AGENDA
PLANNING COMMISSION PUBLIC HEARING/REGULAR MEETING
CITY OF FARMINGTON HILLS
DECEMBER 19, 2024 @ 7:30 P.M.
FARMINGTON HILLS CITY HALL – CITY COUNCIL CHAMBER
31555 W. ELEVEN MILE ROAD, FARMINGTON HILLS, MICHIGAN 48336
Cable TV: Spectrum – Channel 203; AT&T – Channel 99
YouTube Channel: <https://www.youtube.com/user/FHChannel8>
www.fhgov.com (248) 871-2540

**Amend PUD 2, 2021, SP 59-5-2024
 12-476-008, 27400 Twelve Mile Rd.
 Amend Plan to eliminate skilled nursing and
 add single family in RA-1B**

DATE: November 12, 2024
TO: Planning Commission
FROM: James Cubera, Engineering 
SUBJECT: Sarah Fisher Home
Proposed Amended PUD2, 2021
27400 12 Mile Road
PJ#: 12-21-70
SP#: 59-05-2022
22-23-12-276-008

DATE: November 11, 2024
TO: Planning Commission
FROM: Jason Baloga, Fire Marshal
SUBJECT: Amended PUD 2-2021/Site Plan 59-5-2022 (Sarah Fisher Mixed Use Campus)

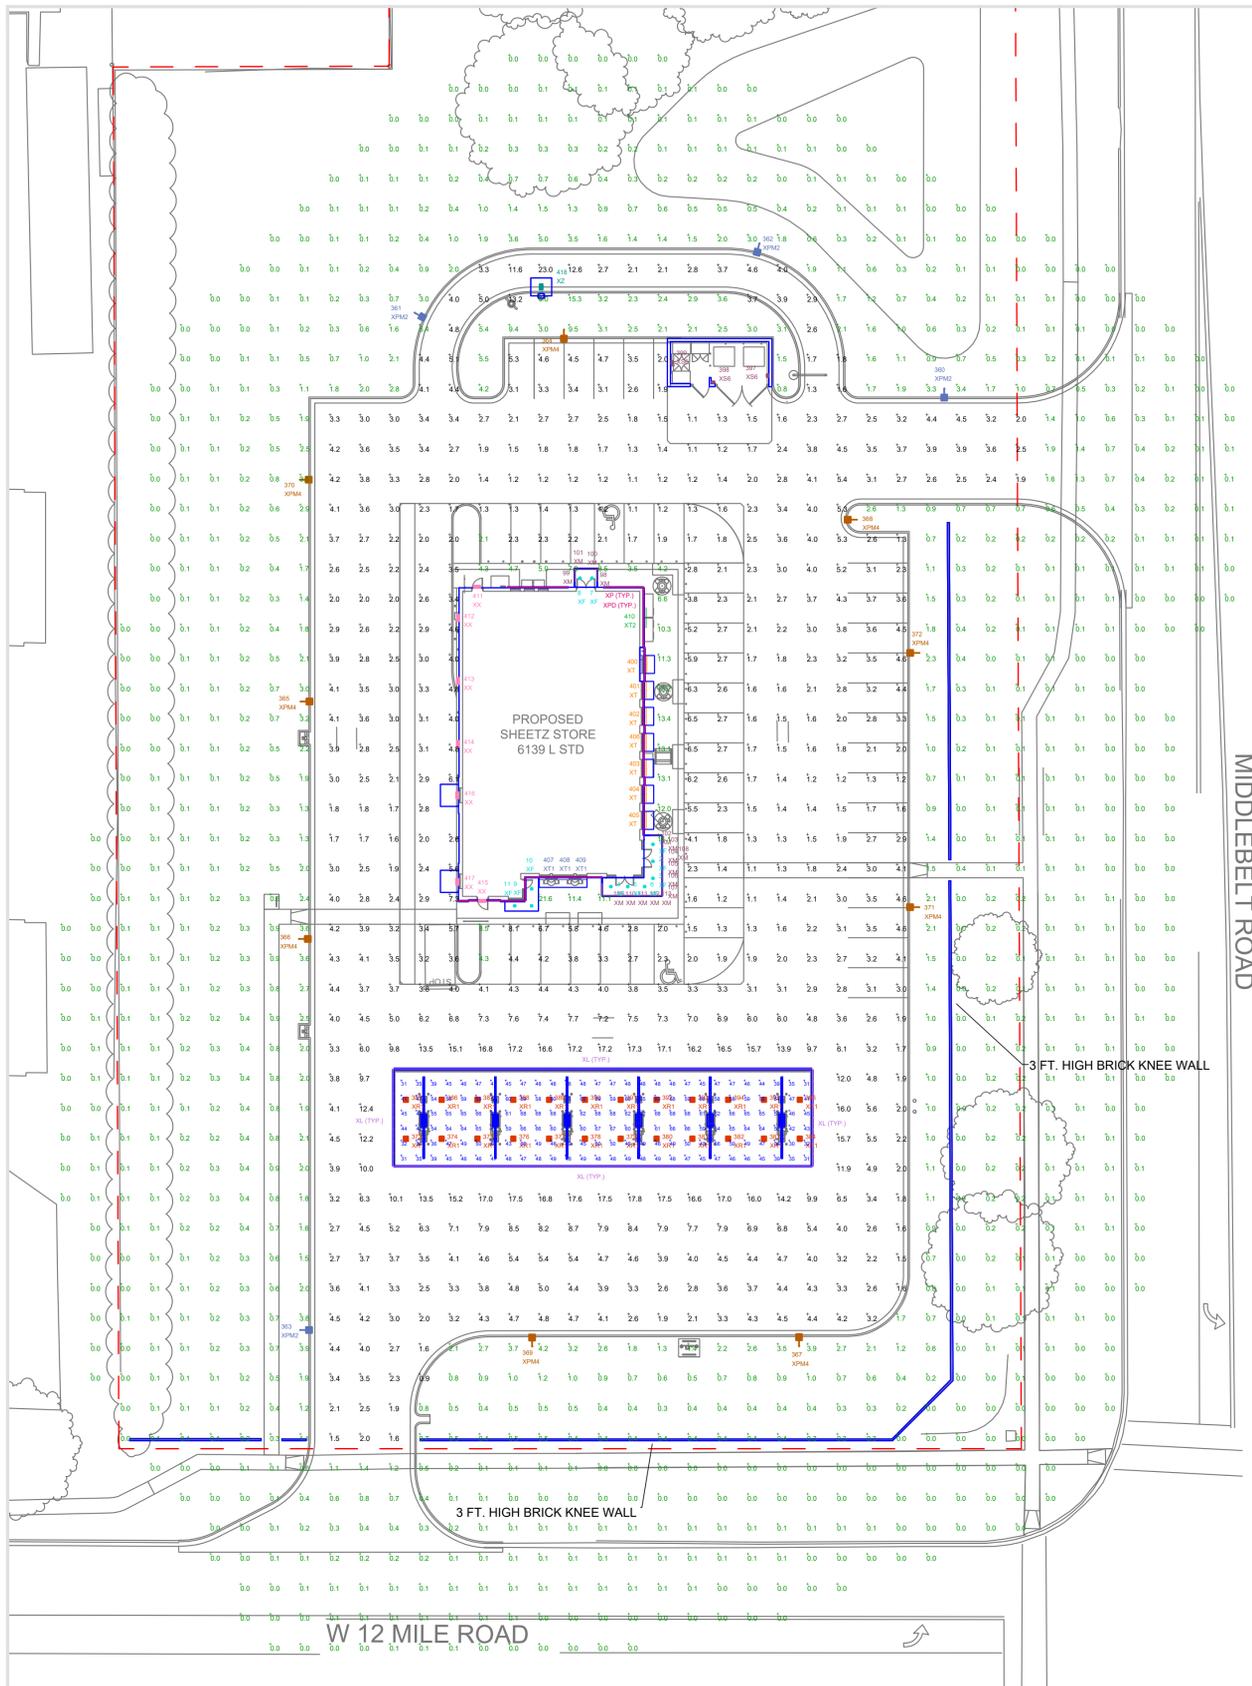
- Sheet A-200 indicates that there will be three wall-mounted signs with the Sheetz logo, while Sheet A-300 indicates there are two Sheetz logo signs and one Made to Order sign. The applicant shall correct this discrepancy.

- Sheet A-200 labels the entry signs as “pole-mounted” signs, but Sheet A-600 details these signs to be monument signs. The applicant shall correct this discrepancy.

- Signs (34-5.5).** The applicant provided sign details, but the plans show some discrepancies. *Sheet A-200 indicates that there will be three wall-mounted signs with the Sheetz logo, while Sheet A-300 indicates there are two Sheetz logo signs and one Made to Order sign. Sheet A-200 labels the entry signs as "pole-mounted" signs, but Sheet A-600 details these signs to be monument signs. The applicant shall correct these discrepancies.* The following review is based upon the sign details provided on Sheets A-300 to A-600.
